**DeKalb County Department of Planning & Sustainability**

**STAFF ANALYSIS**

**Case No.:** SLUP-22-1245550 **Agenda #:** N5  
**Location/Address:** 1799 & 1805 Clairmont Road **Commission District:** 2 **Super District:** 6  
**Parcel ID:** 18-103-03-017, -018  
**Request:** Request for a Special Land Use Permit (SLUP) to allow a drive-through (health services clinic) in the NS (Neighborhood Shopping) Zoning District.  
**Property Owner(s):** Viral Solutions  
**Applicant/Agent:** Ryan D. Jones, PE  
**Acreage:** 0.64 acres  
**Existing Land Use:** Office  
**Surrounding Properties:** To the north of the subject property are a residential parcel and an office use, to the south are medical office uses, to the west is a gas station use, and to the east are townhomes.  
**Comprehensive Plan:** CRC (Commercial Redevelopment Corridor)

Sheet Title  
**SITE PLAN**

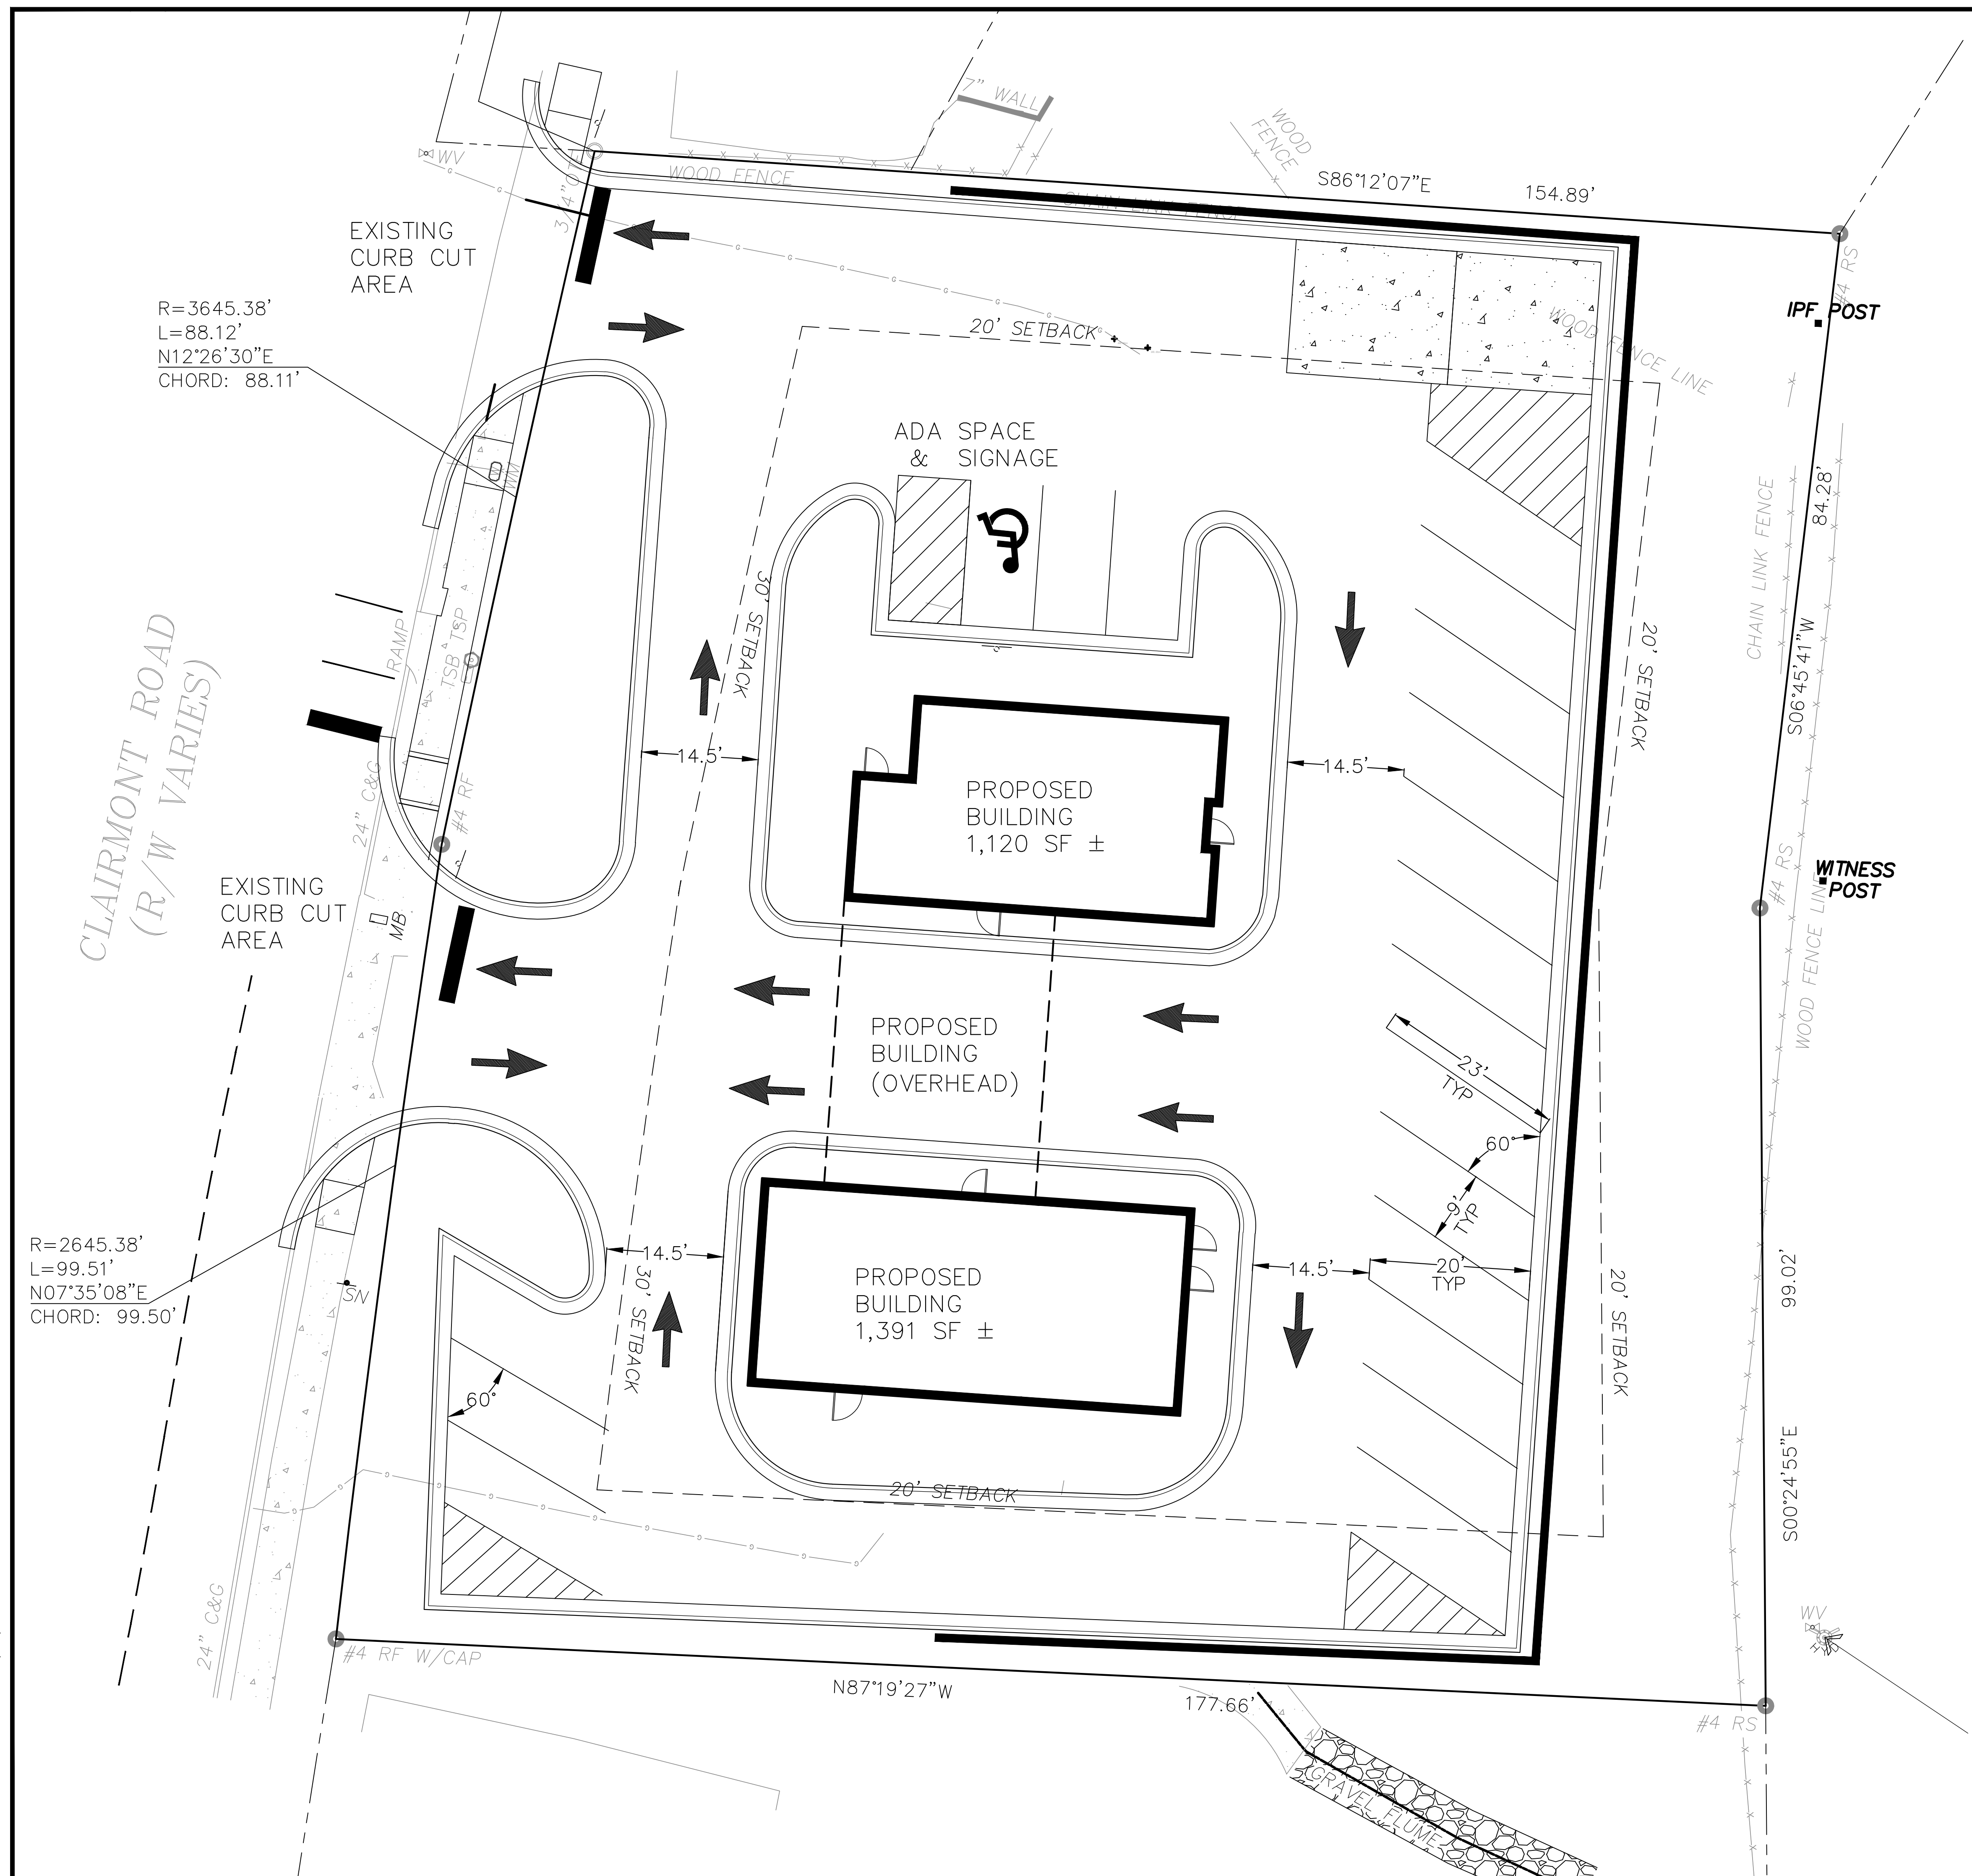
The subject properties are located near the intersection of Clairmont Road and Mason Mill Road. The proposed northern point of ingress/egress into the site is situated at the intersection, however, it is aligned with Mason Mill Road. The proposed southern point of ingress/egress may not be permitted due to its proximity to the intersection along with existing traffic management features (e.g., turning lanes, traffic signals, stop bars, crosswalks, etc.). Secondly, visibility of traffic traveling northbound (i.e., south to north) appears to be limited from 1799 Clairmont Road when exiting the site due to the curvature and decline of the right-of-way.

Additionally, the proposed site plan indicates an intent to “to seek variance to eliminate buffer.” A 50-foot vegetated buffer is required adjacent to residentially zoned properties.

The drive-through lane is proposed through the center of the structure. A variance will be required.

Internal circulation will need to be reevaluated based on changes to site access.

Not addressed.

**Conceptual plan doesn't indicate the location of the stormwater management facility. Concerns are related to the discharge point of the facility. Development/residences are located downstream of the property, and consideration must be given as to where the discharge pipe from the facility is directed as to not create adverse effects. Additional, design professional shall be aware that (1) per county codes, existing conditions must be taken as wooded for the hydrology analysis (meaning existing impervious is not to be considered) and (2) Reduction Reduction Volume is the default water quality.**

**Runoff Reduction Volume shall be provided, unless technical justification is provided as to the unfeasibility. Strongly recommend to investigate the site and identify location where RRv can be provided and re-design/revise the layout to comply with the RRv requirement.**
